SUBJECT: COMANCHE PEAK STEAM ELECTRIC STATION, UNITS 1 AND 2 - AMENDMENT

NOS. 42 AND 28 TO FACILITY OPERATING LICENSE NOS. NPF-87 AND NPF-89

ATTACHMENT TO LICENSE AMENDMENT NOS. 42 AND 28

SAFETY EVALUATION BY THE OFFICE OF NUCLEAR REACTOR REGULATION

FIGURE 5.1-3
UNRESTRICTED AREA AND SITE BOUNDARY FOR RADIOACTIVE GASEOUS
AND LIQUID EFFLUENTS

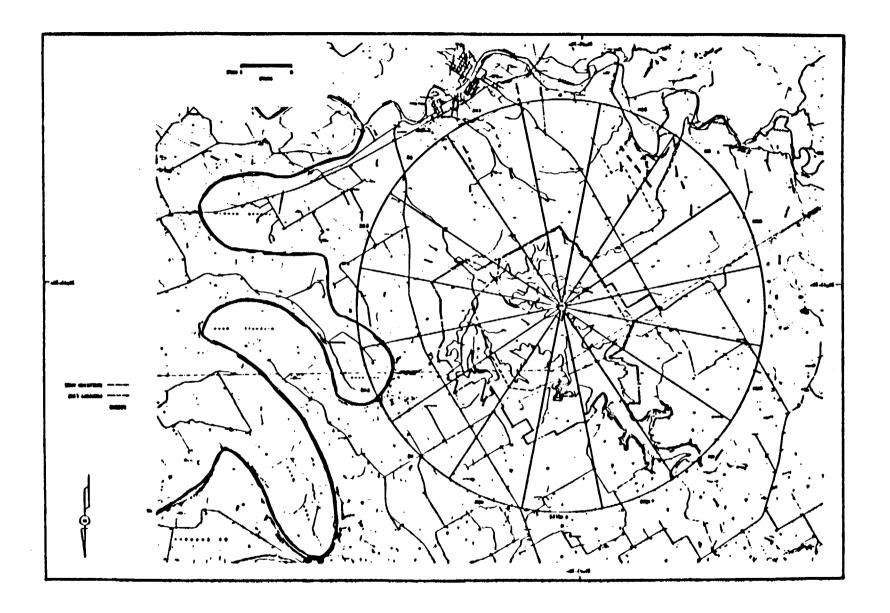
3. TS 5.1.3 Map Defining Unrestricted Areas and Site Boundary for Radioactive Gaseous and Liquid Effluents

The licensee proposed to change the reference from "10 CFR 20.3(a)(17)" to "10 CFR 20.1003" and update the map (Figure 5.1-3) to add a clarifying note with respect to areas for which TU Electric controls access.

The change is administrative in nature to incorporate the corresponding revised 10 CFR Part 20 section number and is acceptable.
